ADDENDUM NO. 1

**RE: POINSETTIA COMMUNITY PARK PHASE IV, PROJECT NO.: 4608
BID NO. PWS21-1452PKS**

**Poinsettia Community Park Phase IV – Dog Park,
Restroom & Parking Lot**

Addendum No. 1

SINGLELINE DIAGRAM AND SCHEDULES FOR: POINSETTIA COMMUNITY PARK PHASE IV DOG PARK RESTROOM & PARKING LOT SE-2.0

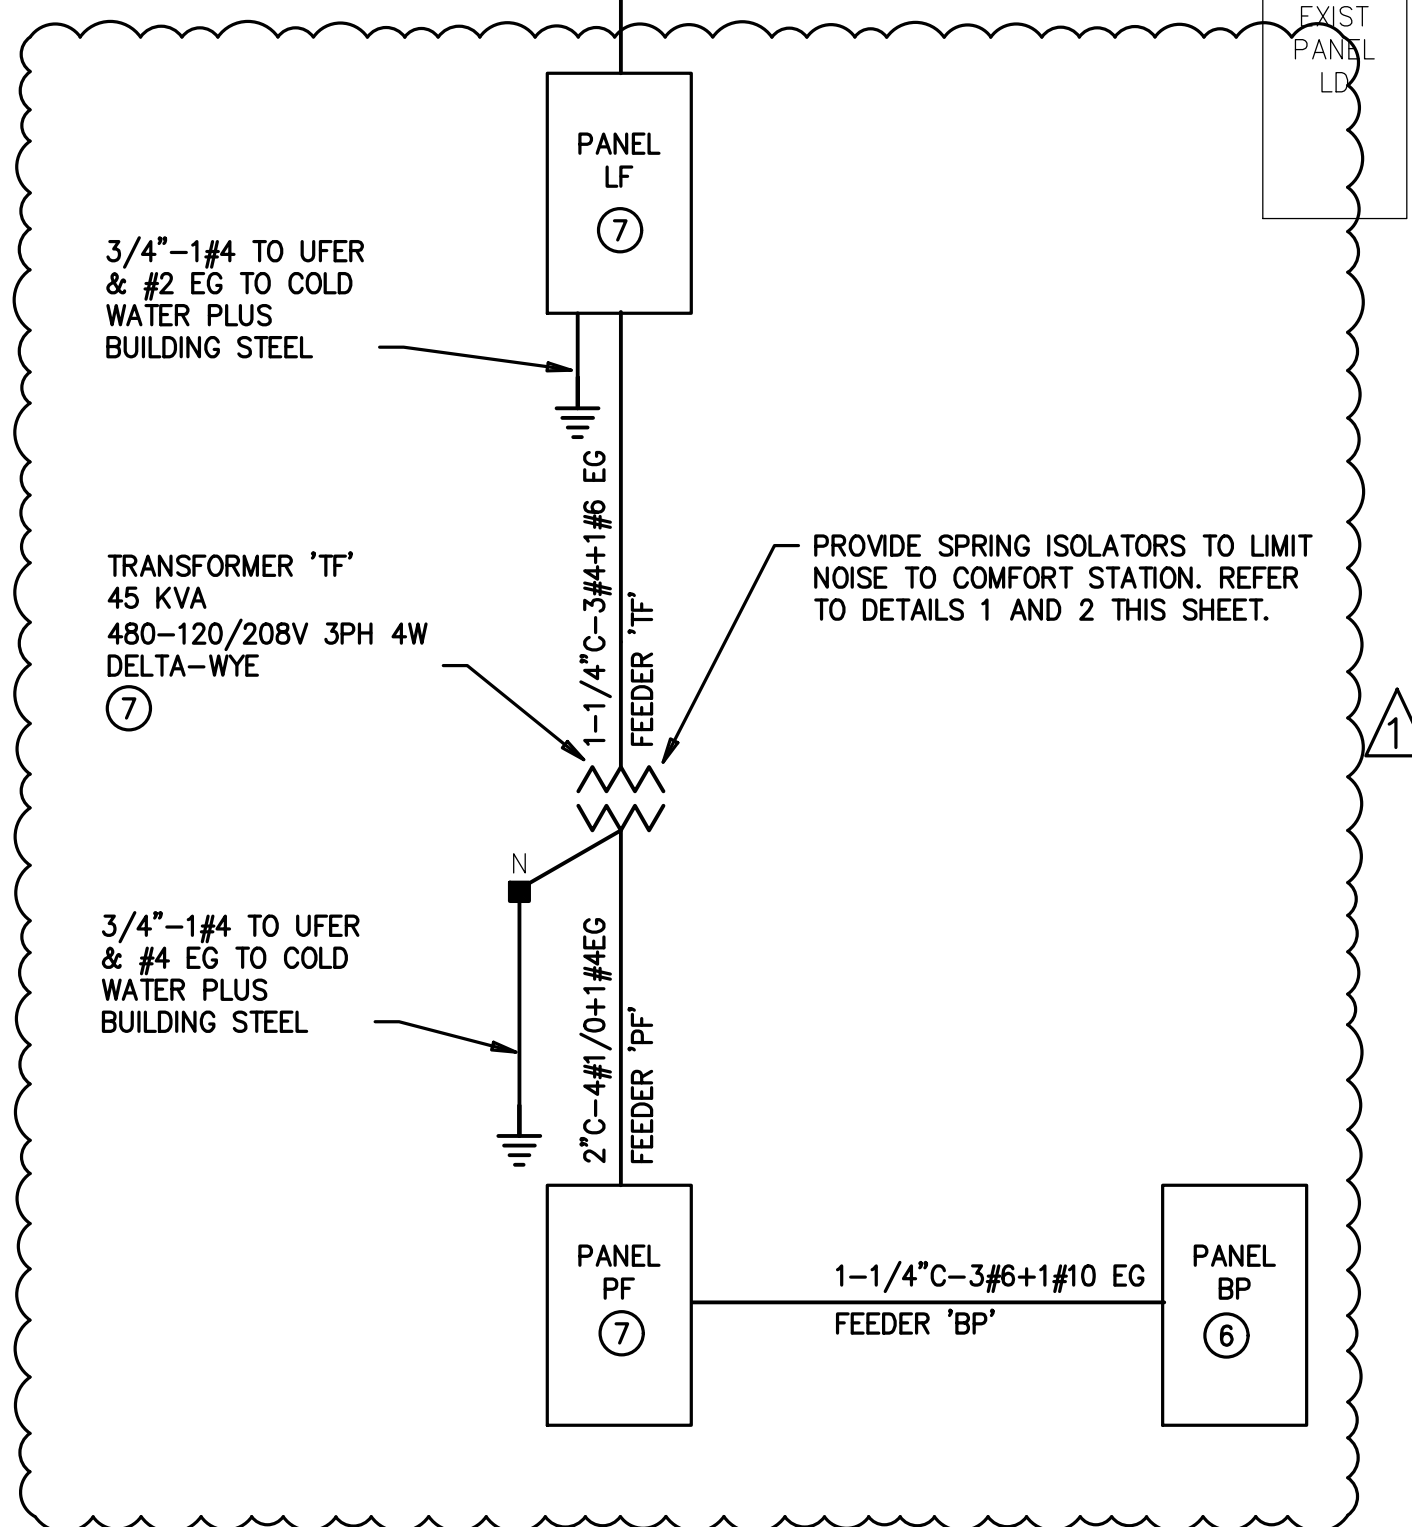
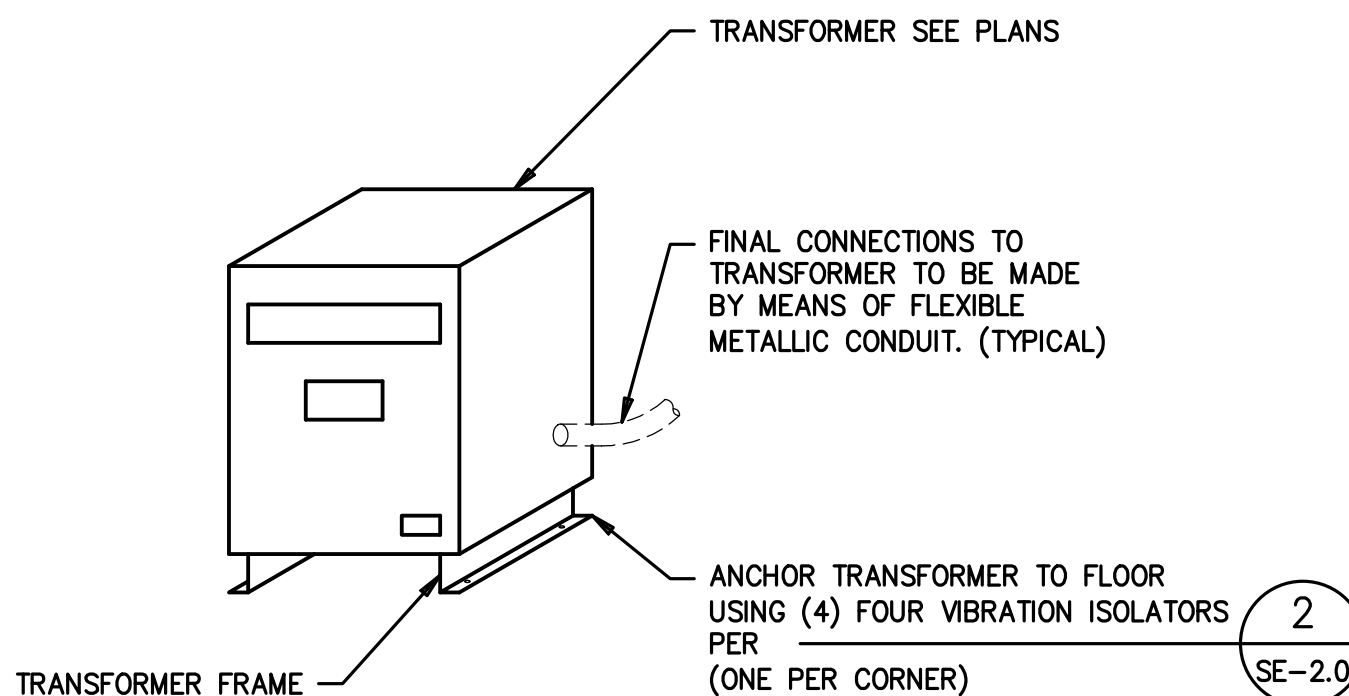
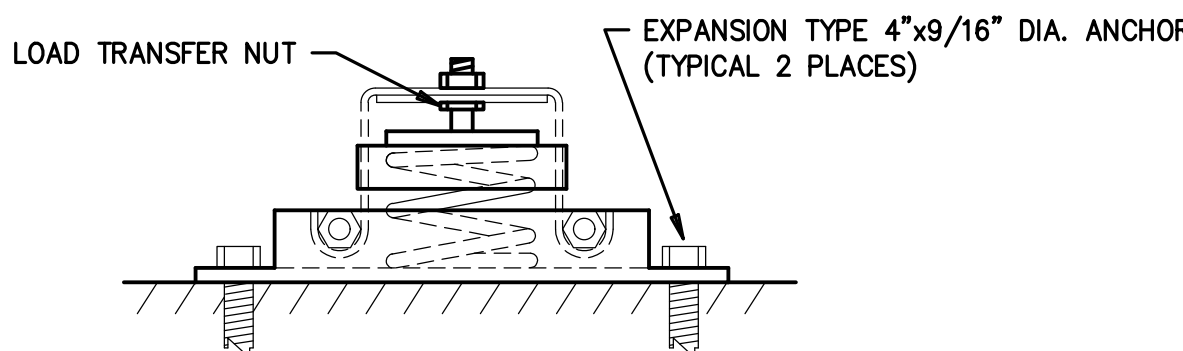
Electrical Plan sheets SE-1.1 and SE-2.0 (Page Nos. 10 and 13) have been revised. Update includes minor revisions to the plans shown in clouded areas identified as Delta 1. **Replace sheets in the Poinsettia Community Park Phase IV Construction Documents with revised sheets SE-1.1 and SE-2.0, attached herein (Attachment E).**

5/10/21 NJA DELTA 1 - ROMTEC COORDINATION

- EXISTING GROUND CONNECTIONS TO REMAIN.
- MAIN 1600 AMP FUSE AT MSB LIMITS FAULT CURRENT TO LESS THAN 22,000 AMPS.
- EXISTING MAIN NEUTRAL TO GROUND LINK.
- PROVIDE FUSED DISCONNECT IN EXISTING SPACE TO MATCH EXISTING IN TYPE AND AIC RATING.
- ROUTE IN EXISTING CONDUIT WITH EXISTING 2#10. REMOVE AND REPLACE EXISTING CIRCUIT TO FACILITATE BULL.
- PANEL IS TO BE PROVIDED WITH PRE-ENGINEERED RESTROOM BUILDING. REFER TO ROMTEC DRAWINGS FOR PANEL SCHEDULE.
- PANEL 'LF', TRANSFORMER 'TF' AND PANEL 'PF' ARE TO BE PROVIDED BY THE CONTRACTOR AND INSTALLED IN THE ROMTEC PRE-ENGINEERED RESTROOM BUILDING.
